**Appl. No.** : **10/770,884**  
**Filed** : **February 2, 2004**

16. AMENDMENTS TO THE DRAWINGS

## REMARKS

FIGURE 2

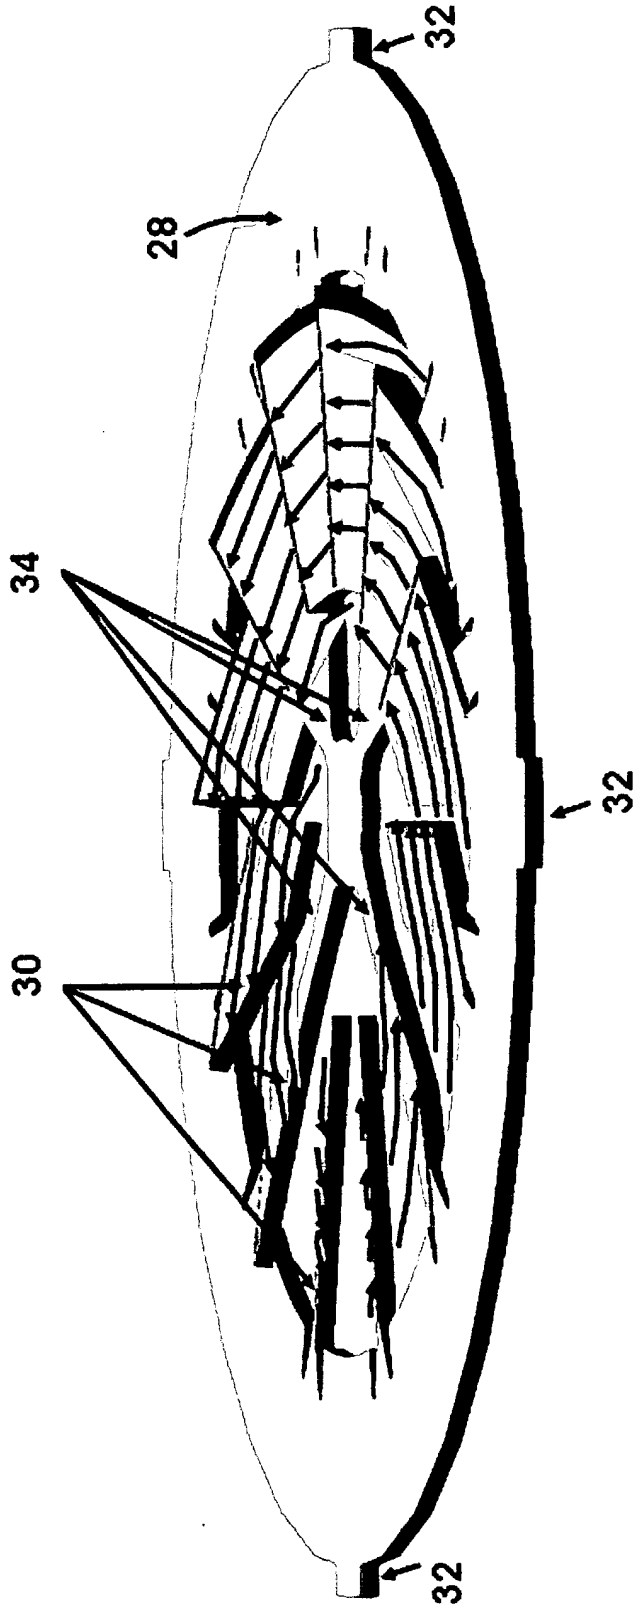
The drawings of Figure 2 have been corrected to refer to "heat reactor housing."

Corrections include:

Text (Combustion Chamber) has been changed to read (Heat Reactor Housing)

Figure 4

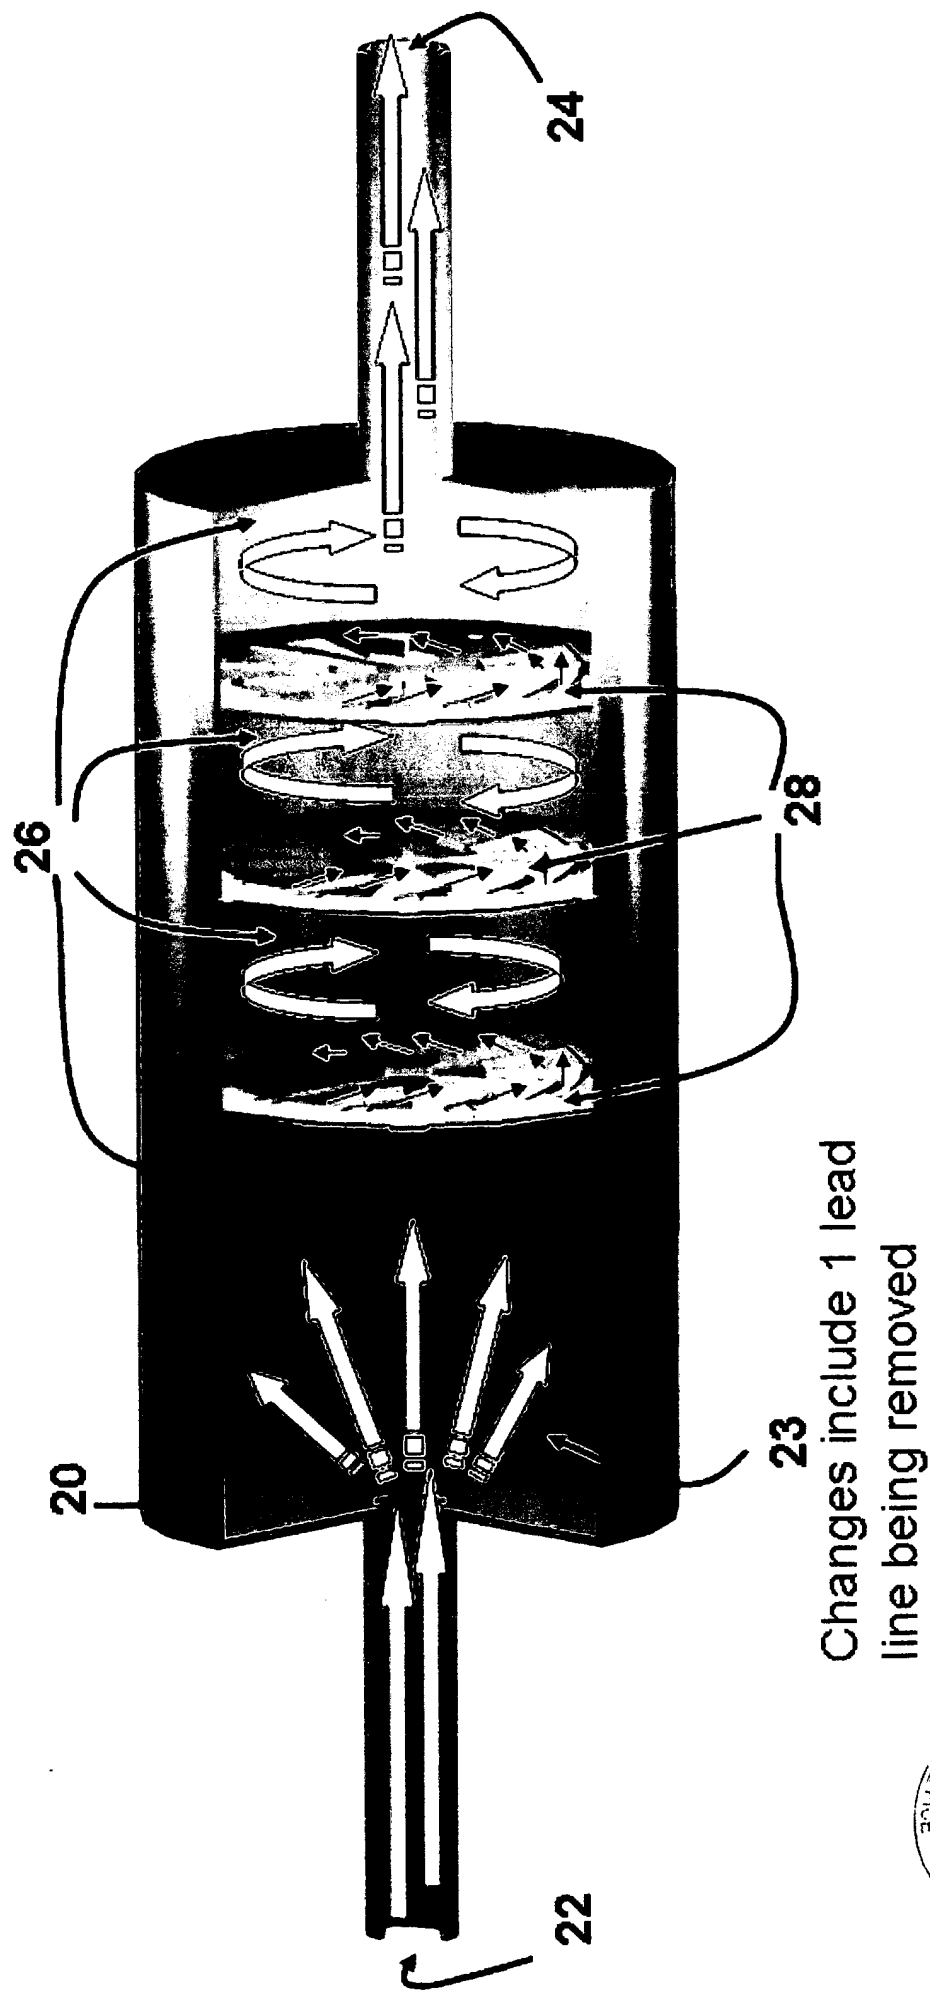
Changes include corrected margins and  
deletion of arrows indicating flow
